AGENDA
Cascade Charter Township Planning Commission
Monday, March 06, 2017
7:00 pm
Cascade Library Wisner Center
2870 Jacksmith Ave. SE

STAFF REPORT

TO: Cascade Charter Township Planning Commission
FROM: Steve Peterson, Community Development Director
REPORT DATE: February 28, 2017
MEETING DATE: March 6, 2017
CASE: #17-3367 -Cascade One

- D. Requested Action: Rezone to P.U.D. to allow for 31 lot plat.

SITE PLAN OF The Meadows at Abbeydale

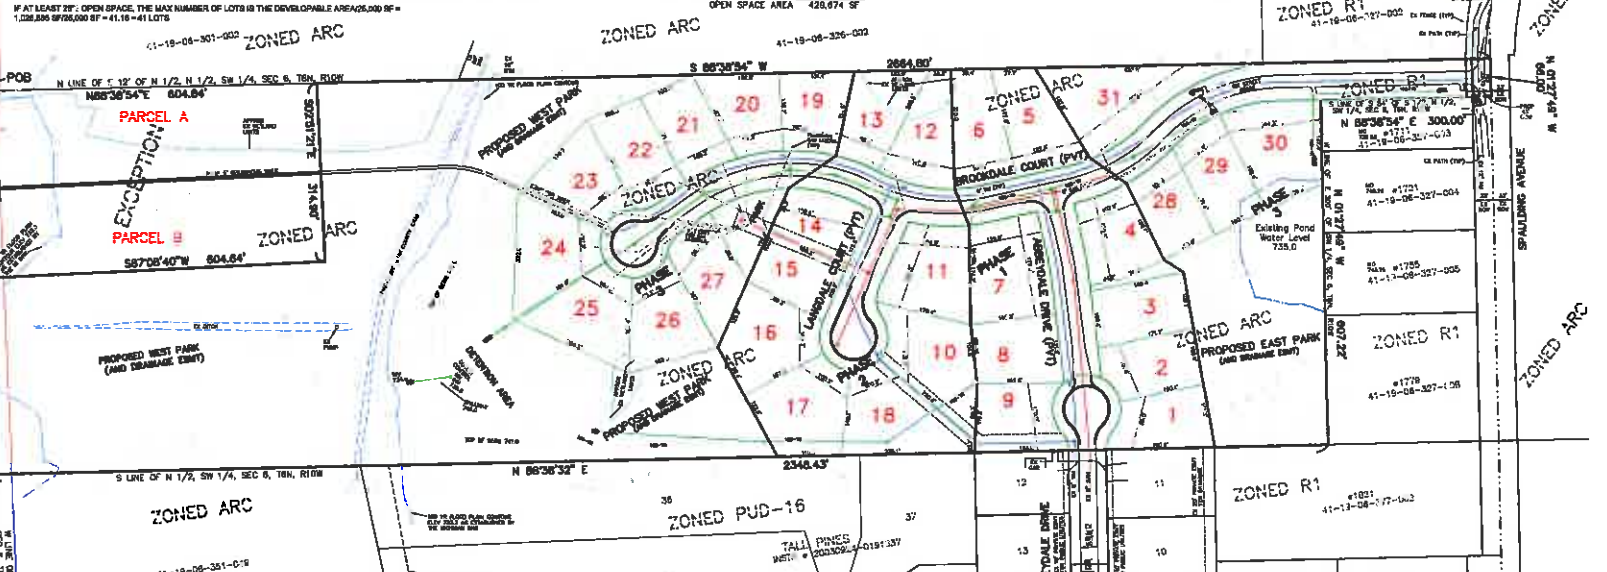
- E. The subdivision includes the use of new private roads. This is a change from the old project. The main reason for the change is the KCRC design standards could not be met while still meeting the drainage requirements (However, as late as 3/1/17, the KCRC still thinks that their design can be met). The Township's private road design standards will still have to be met. There is a section of the road that exceeds our 6 % limit. Our engineer has the ability to recommend up to 8% grade. You will be asked to evaluate this. The road names will need to be approved by KCRC.

- G. The Township Engineer will also need to review and approve the Storm water plan for this project.
- H. They do include access to Spaulding and Abbeydale. As a private street development we require a second access point to a public street after 19 home sites. With private street the new development may wish to use gates to restrict access. We should discuss this as a connection from Abbeydale to Spaulding is desirable for not only the new subdivision but also those in the existing subdivision. It would make sense to restrict the ability of the developer to cut off access and allow access from Abbeydale to Spaulding Ave.

- I. The plan does include a pedestrian connection to our path from Spaulding using the new private roads. We should discuss whether or not to allow the connection using the private roads or if a new sidewalk should be built. This connection is important but we need to talk about the best way to make the connection and the long term maintenance plan for the path. According to the City of Kentwood, the Kent County Drain Commission and the designing engineers of the subdivision in Kentwood, the stub street was designed to connect to this property in Cascade. This would provide an excellent connection from Cascade into Kentwood.

- J. The plans do not include sidewalk for the project, which is a requirement of our subdivision ordinance. A separated sidewalk similar to Manchester/Stoneshire and Watermark that would connect from Spaulding Ave to the walk going to Kentwood should be included.

- N. They have NOT submitted a test plan showing how they could do the same 31 lots without needing PUD rezoning approval. This plan will need to be submitted and evaluated ensure that the number of lots they are proposing is actually possible.

- O. The site is impacted by some small wetland areas which should be evaluated for need of any MDEQ permits.
- P. The applicant is attempting to use the 25% open space development technique for this project. The open space or common areas need to be clearly identified on the plan, along with a plan showing how they calculated the density to make sure it fits with our subdivision ordinance.

- R. The plan includes an area about 3.8 acres in size that they are leaving out of the project. This area has direct connection to Cavaclade Dr in Kentwood. This area would be able to accommodate two parcels. Similar to the subdivision portion it appears that the connection is being made using a driveway rather than a separated sidewalk. I would prefer a connected sidewalk.

1. Review by KCRC, including the possibility of utilizing public streets.
2. Provide a test plan.
3. Revise the plans to show a sidewalk connecting from Spaulding Ave to the walk going to Kentwood, including the exception area.
4. Address stormwater, sanitary sewer and public water supply issues with the Township Engineer.
5. Have plans reviewed by the KCDC
6. Provide comments from the MDEQ regarding the need for any permits from the State.
7. Provide comments from the City of Kentwood regarding your connection to Cavalcade.
